**ANSI/ASHRAE Addendum h to
ANSI/ASHRAE Standard 15-2016**

Safety Standard for Refrigeration Systems

Addendum h to Standard 15-2016

Figure 8.13.11.4-1 (a) Level 2 ventilation rate for Class 2L refrigerants (I-P) with (b) detail.

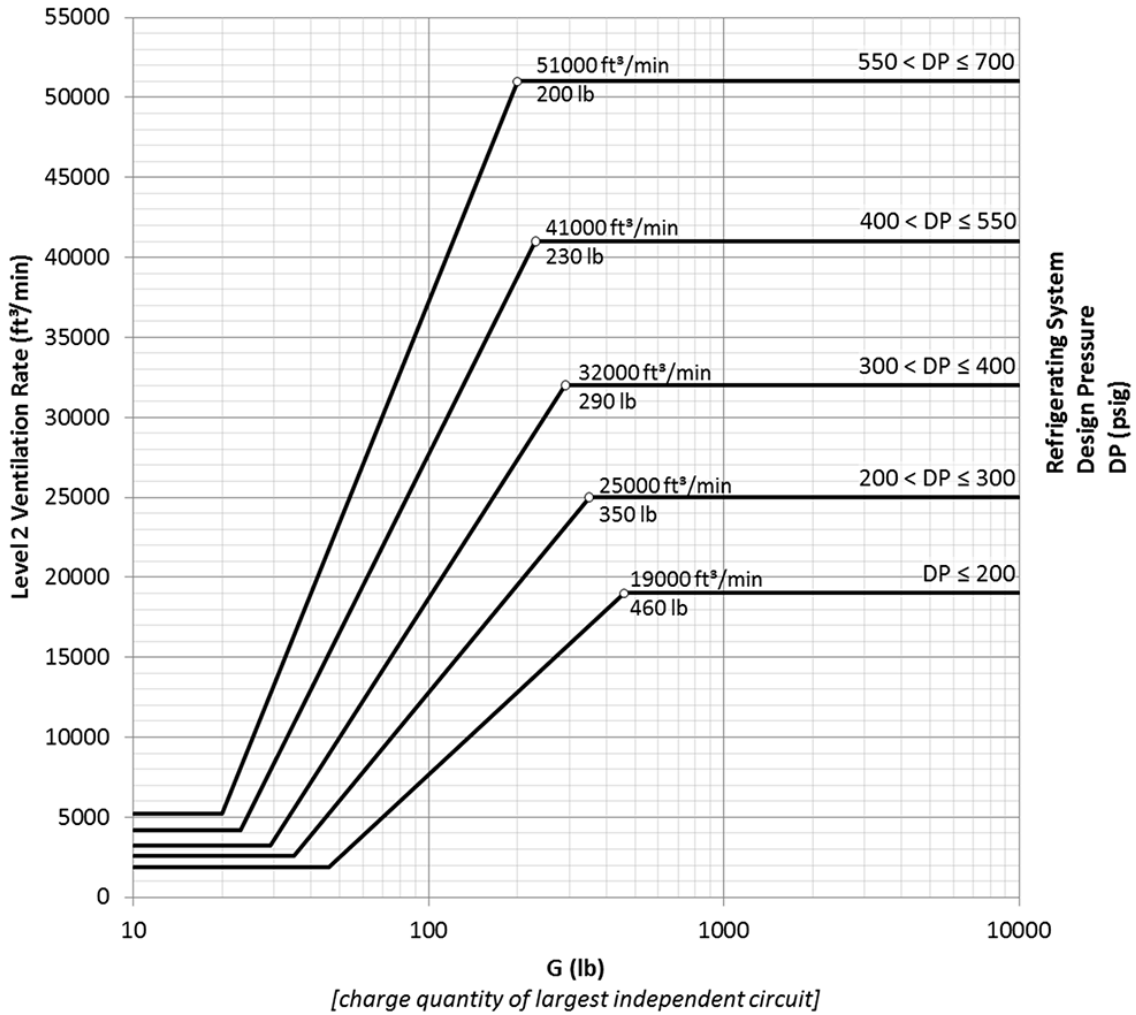
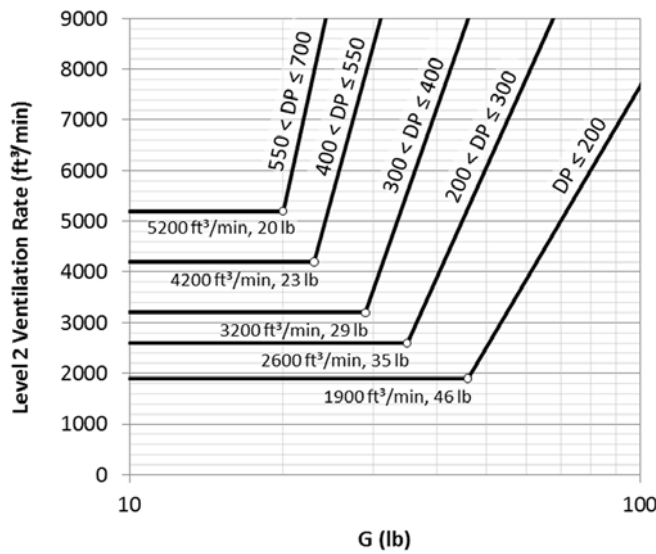
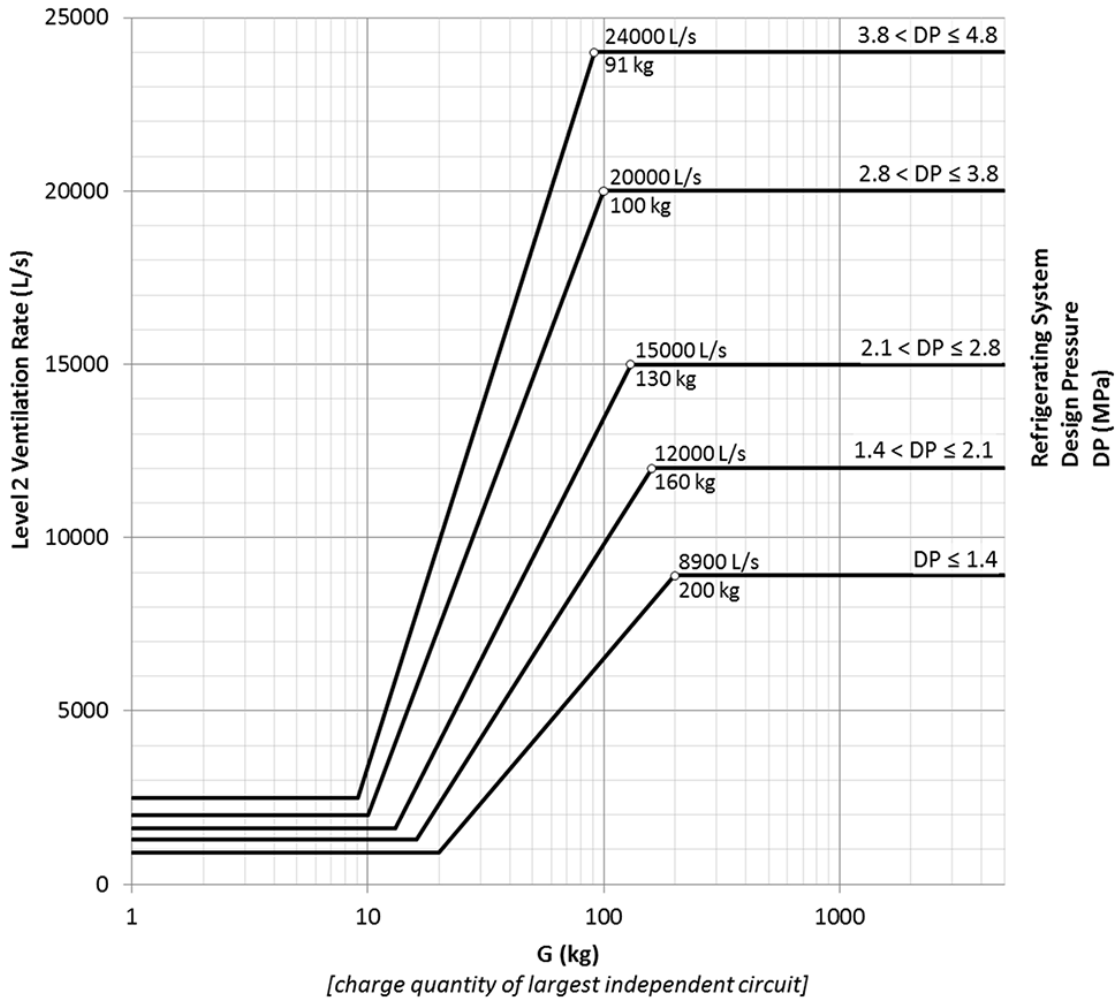
8.13.11.4 Safety group A2L, B2L Other than Ammonia. When required by Section 8.13.11.3, the total airflow for Level 2 Ventilation shall be not less than the airflow rate determined by Figure 8.13.11.4-1 (I-P) or Figure 8.13.11.4-2 (SI).
